Case No. P16-10

**Highpoint Subdivision
(Northwest corner of S. Court & Highpoint Dr.)**

CITY of MEDINA
Planning Commission
May 12, 2016 Meeting

Subject: South Court Village Development – Final Plat

SOUTH COURT VILLAGE

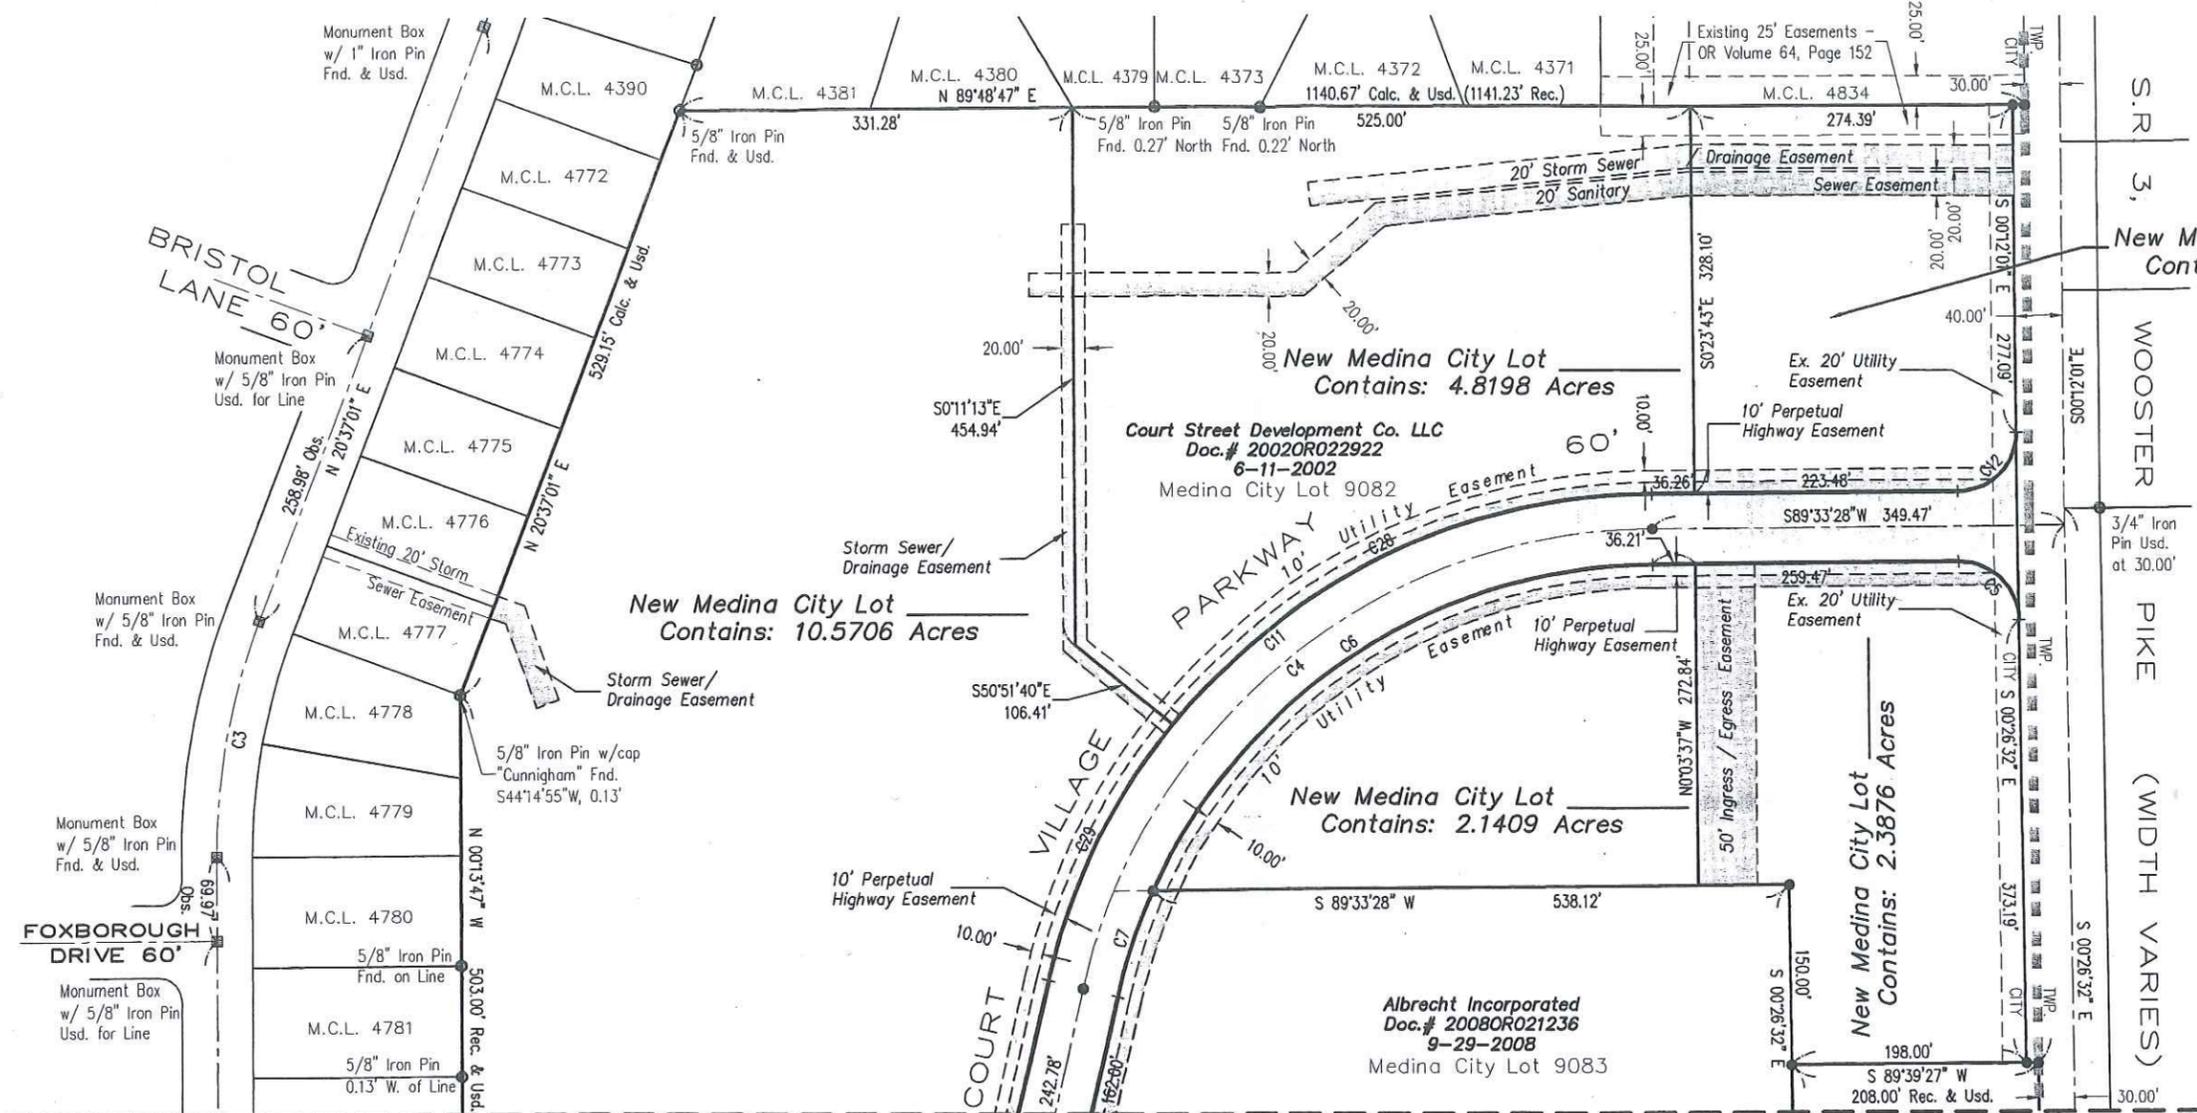
- a. Copy of restrictive covenants pertaining to the site, if applicable
- b. Change the name of the proposed local street. "Court Village Parkway" is too similar to the adjacent "South Court Street" per Section 1169.05(b)(4)
- c. Depict the center island of the roundabout/cul-de-sac of the proposed street and indicate it as under the ownership and maintenance of the private property owner.
- d. Reference adjoining platted parcels by name, volume and page per Section 1169.05(b)(10) Certification area and seal for the registered surveyor representing that the plats details are correct as required by Section 1169.05(b)(11)
- e. Acceptance of offers of dedication by Council per Section 1169.05(b)(13)(D)

1. Incorporate the additional information below on the proposed final plat:
 - a. Copy of restrictive covenants pertaining to the site, if applicable
 - b. Change the name of the proposed local street as “Court Village Parkway” is too similar to the adjacent “South Court Street” per Section 1169.05(b)(4)

- c. Depict the center island of the roundabout and indicate it as under the ownership and maintenance of the private property owner. A separate, non-buildable parcel needs to be established for the roundabout.

- d. Reference adjoining platted parcels by name, volume and page.
 - e. Certification area and seal for the registered surveyor representing that the plats details are correct as required by Section 1169.05(b)(11)

- f. Acceptance of offers of dedication by Council per Section 1169.05(b)(13)(D)
2. Coordinate with the Parks and Forestry Department to comply with the street trees requirements of Section 1173.03(f).

2.1. The construction plans reflect an island to be installed within the cul-de-sac at the southern end of the new street. Please be advised that the City requests that the final plat be modified to create a non-buildable City lot encompassing the island. Further, this new lot must be deeded to a private entity which will be responsible for maintenance of the island in perpetuity.
